CITY OF SOUTHGATE PLANNING COMMISSION AGENDA

1. Planned Development (PD) Site Plan Amendment, 15601 Northline

1. Conditional Use Review, 15446 Fort
2. Site Plan Review, 15446 Fort

OVERALL SITE PLAN

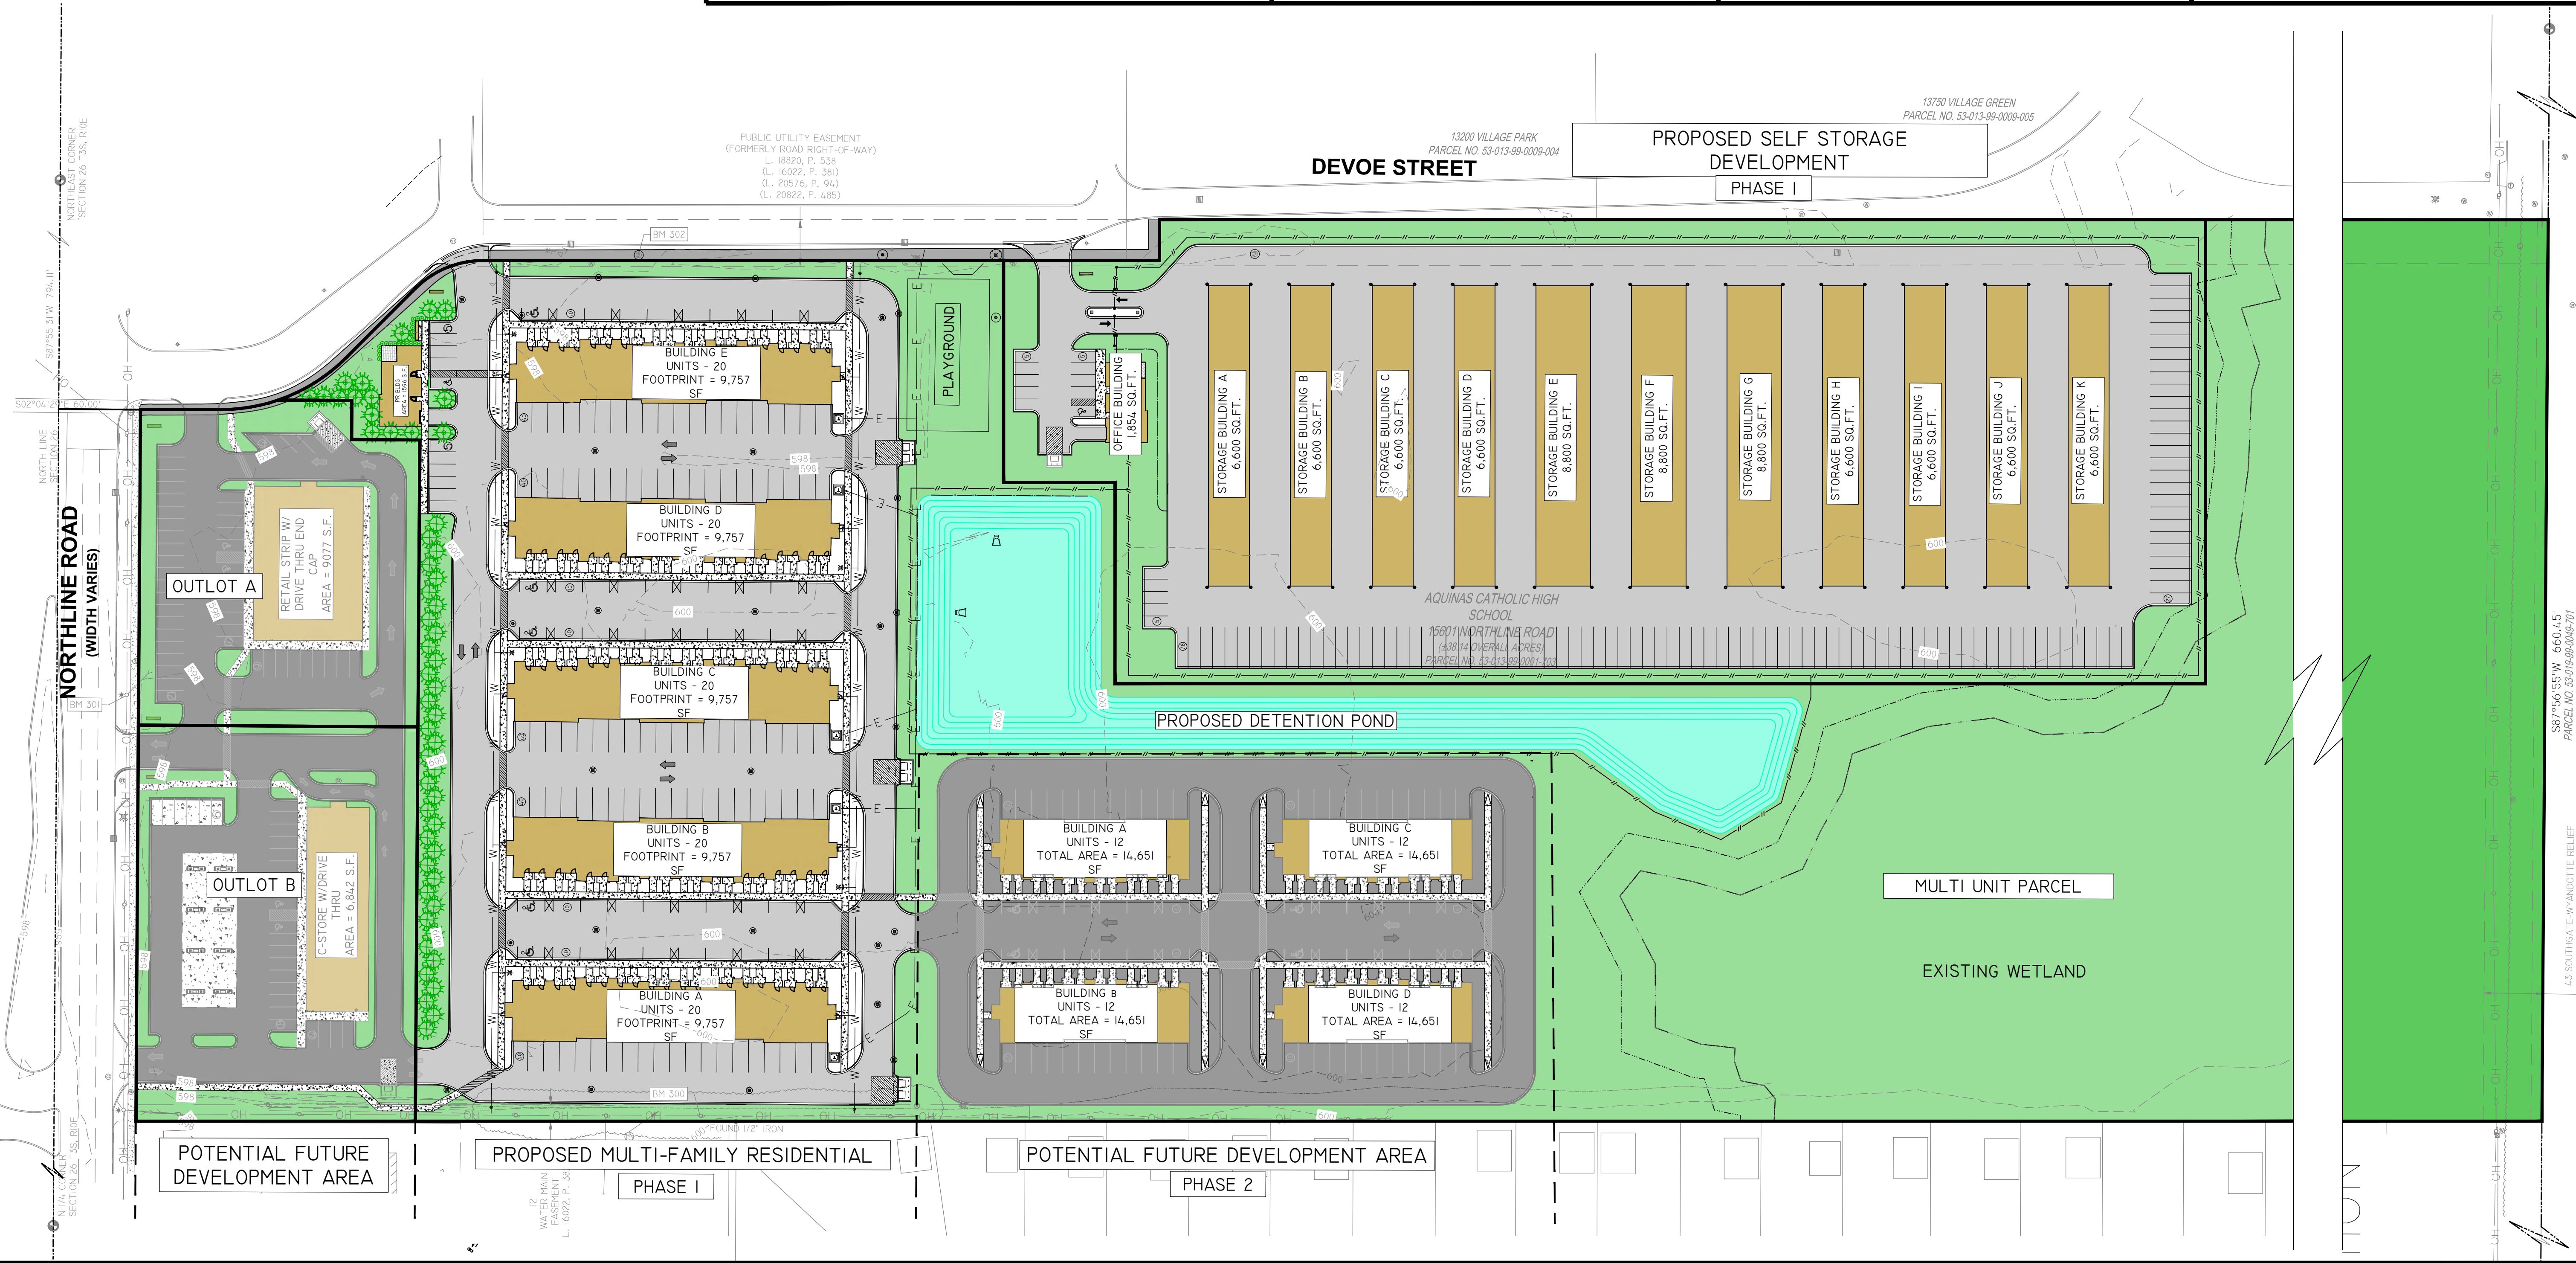
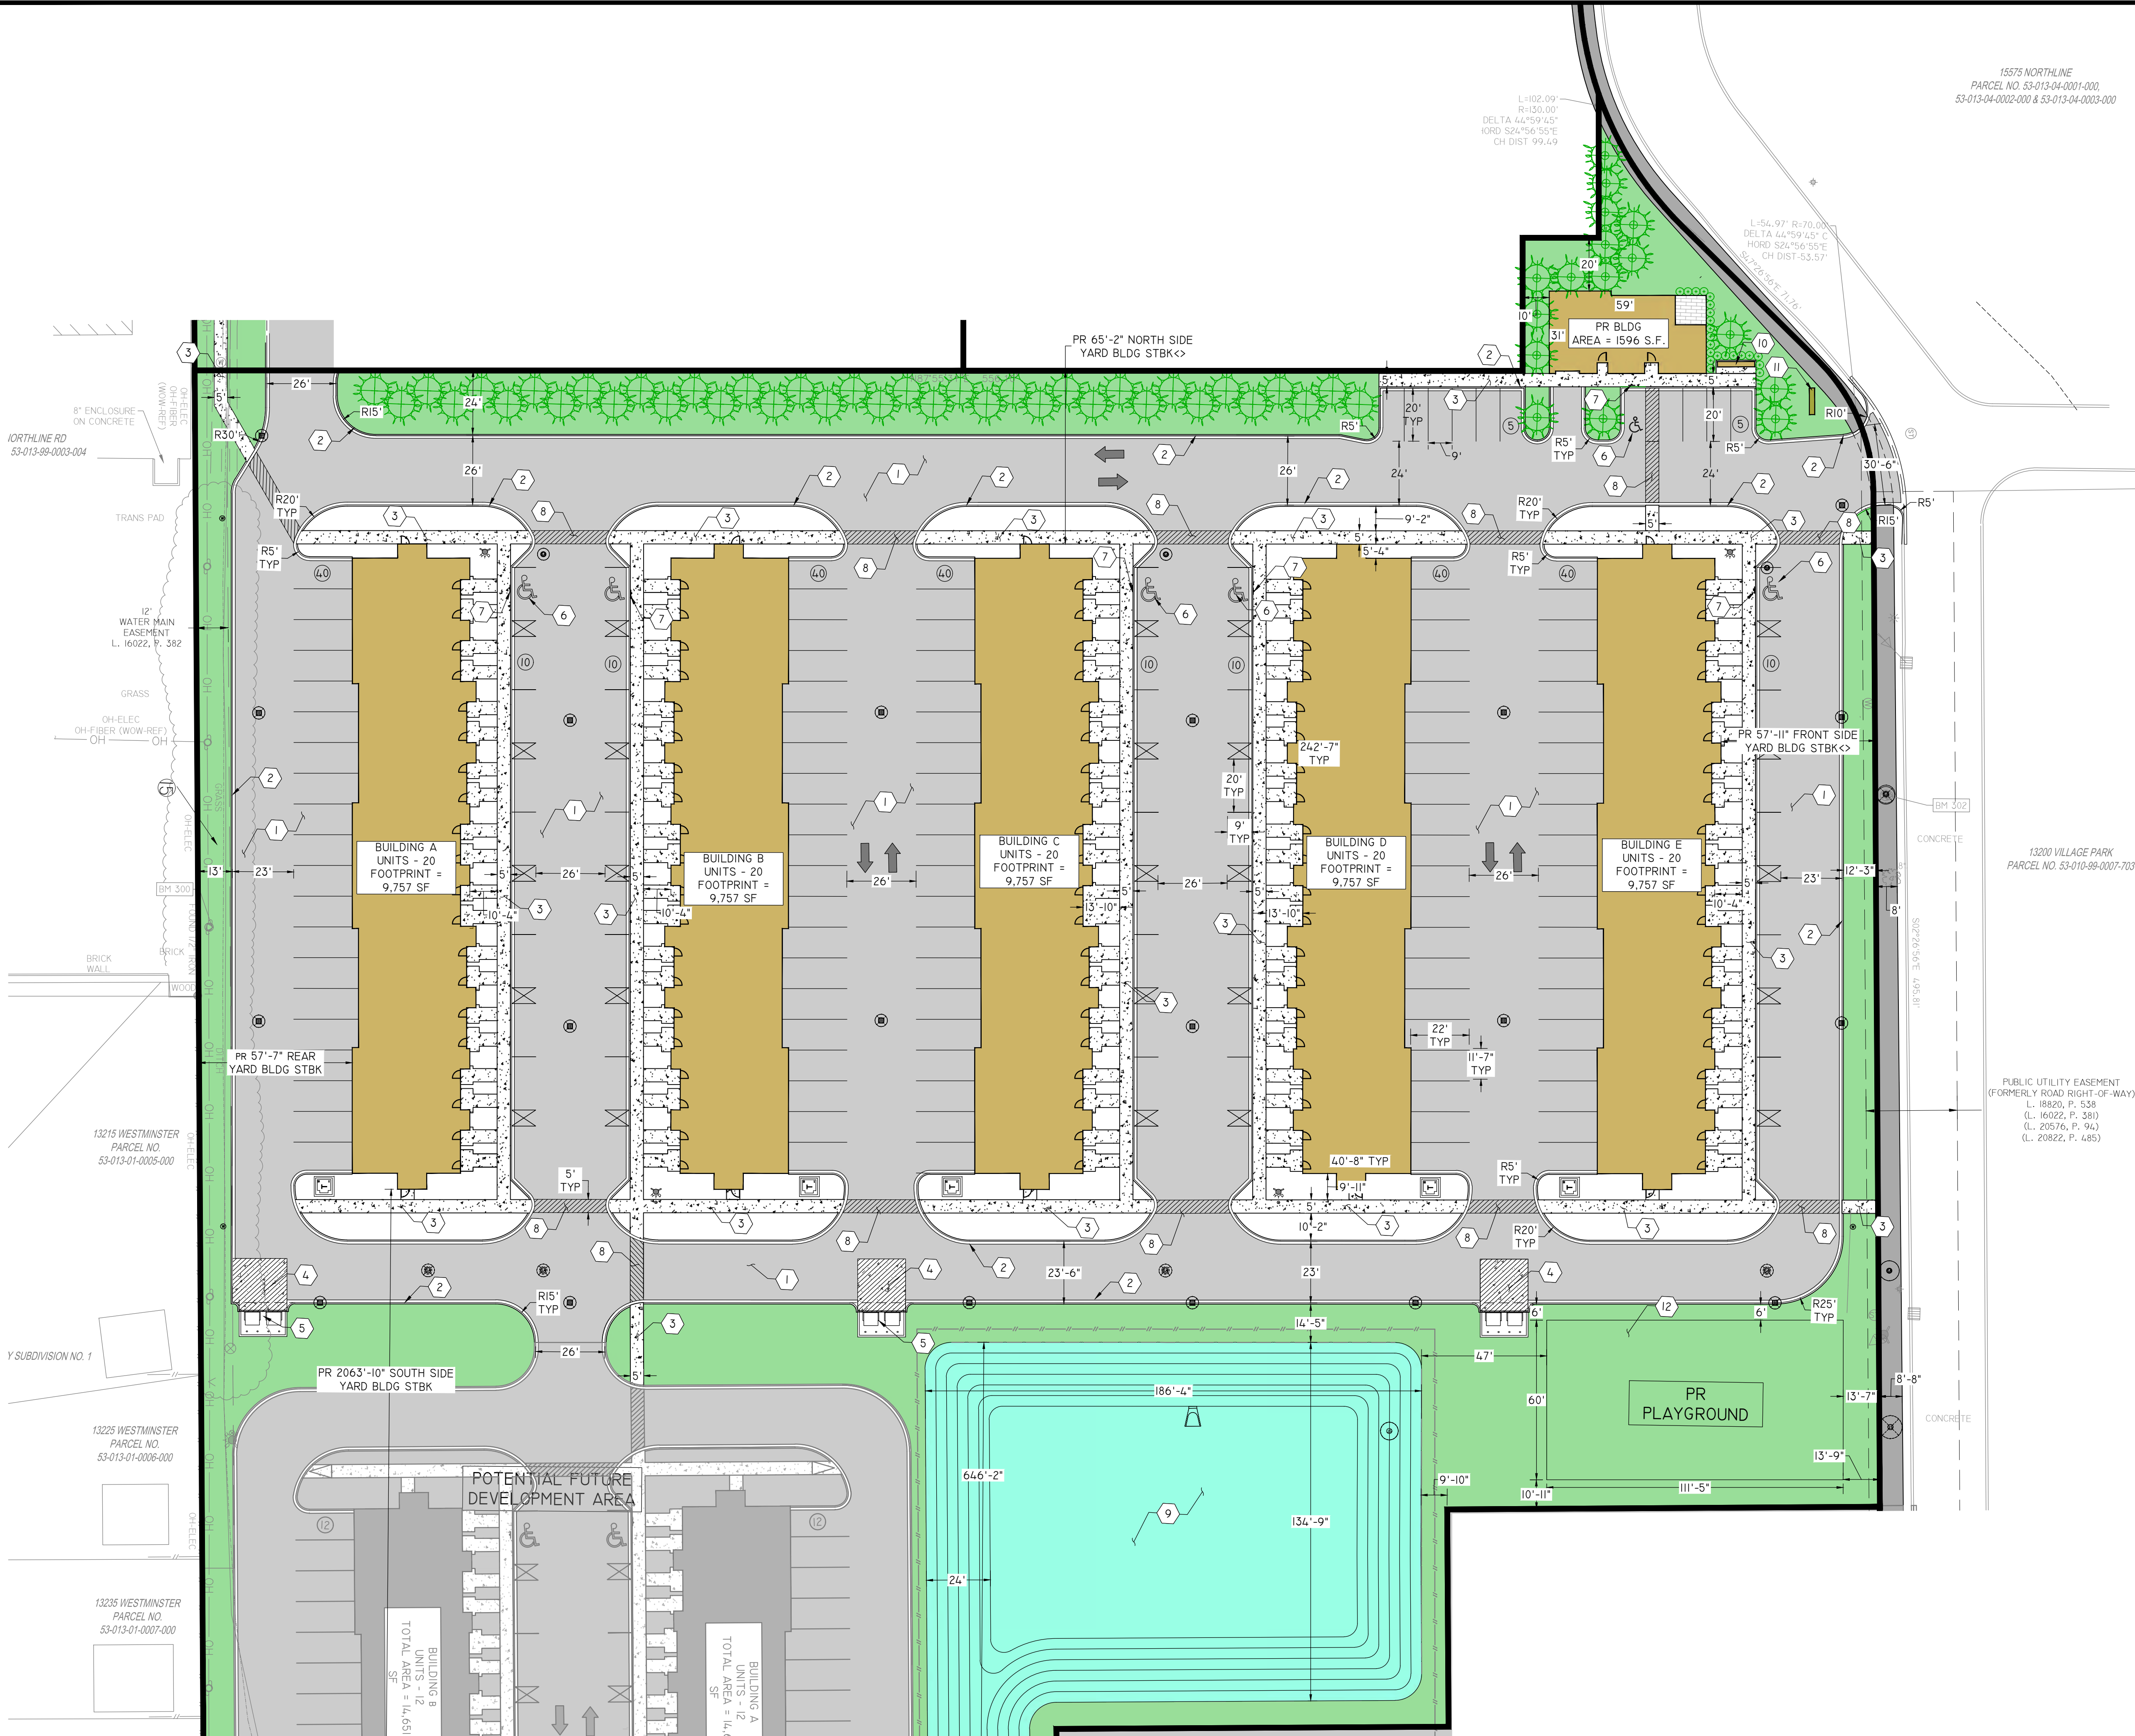
CWA Comment: The multi-family and self-storage buildings proposed in phase 1 contain frontage along Devoe Street, which is designated as a public City Road. Sheet C3.0 calls out a public utility easement as a former right-of-way. Further clarification is needed to confirm the 50-foot setback distances. The self-storage buildings show a 48-foot setback from the edge of Devoe Steet, and the phase 1 apartment buildings have a 50-foot setback from the edge.

**OVERALL
LANDSCAPE
PLAN VIEW**

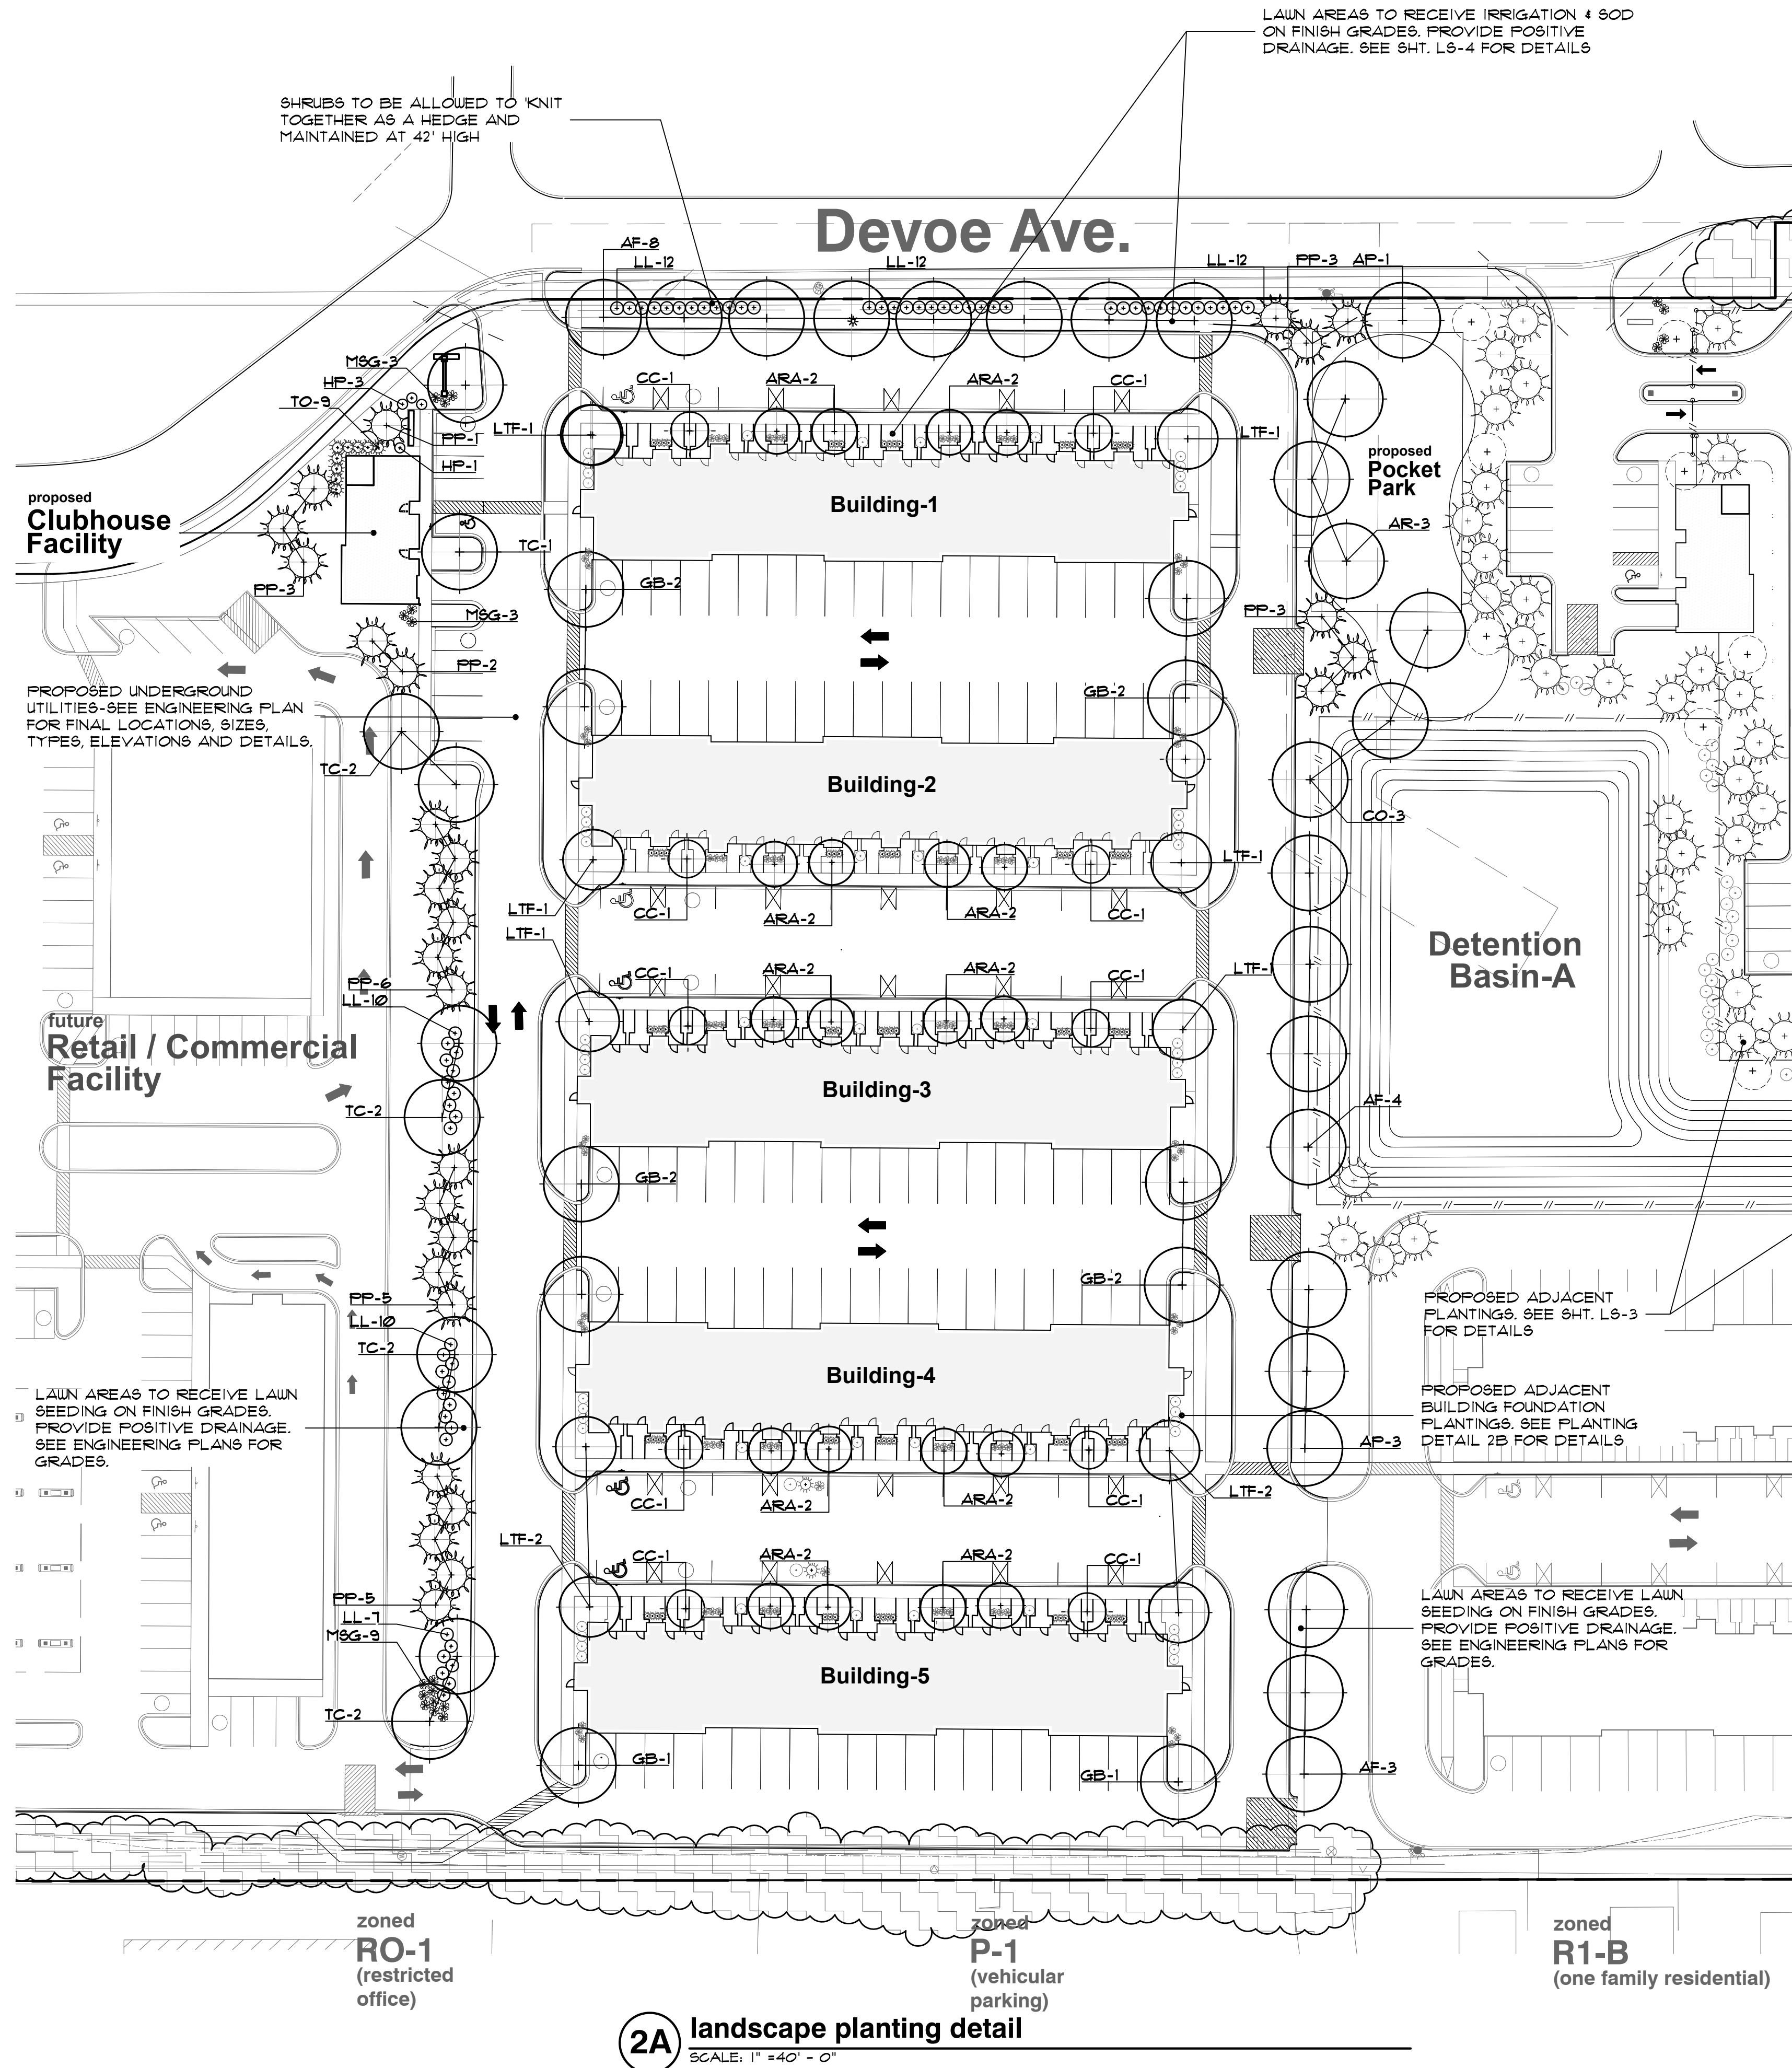
A landscape plan has been provided on sheets LS-1 through LS-6.

Street Trees:	Seventeen (17) deciduous trees consisting of Colorado Spruce and Red Maples are shown along Devoe Street, extending from the northern edge of the phase 1 apartment buildings to the northern edge of the self-storage parking lot. Forty-eight (48) deciduous shrubs are also proposed along Devoe Street. A callout on sheet LS-2 indicates that lawn areas will be sodded and irrigated.
Use Screening:	Landscape screening is shown between the retail/commercial Lots A and B and the phase 1 apartment buildings, which include twenty-six (26) deciduous trees and thirty-six (36) deciduous shrubs, which contain Morning Light Japanese Silver Grass plants which will need to be replaced due to its flammability characteristics and invasive status. Switchgrass may be an appropriate alternative that provides similar height and size. Between the self-storage and Phase 1 apartment buildings, forty-one (41) deciduous trees are proposed. Between the self-storage and Phase 2 apartment buildings, sixteen (16) deciduous trees are proposed. Additional trees should be considered near Building C of Phase 2, particularly along the detention basin frontage, to improve buffering and visual aesthetics.

Per section 1298.09, a landscape plan shall also consist of planting cross-section details, which has been provided on sheet LS-4. A planting schedule including plant species and caliper planting size has been provided on sheets LS-2 and LS-3. We recommend adding more evergreen plantings, specifically between the apartment buildings and the self-storage and commercial lots A and B to ensure a year-long screen is provided.
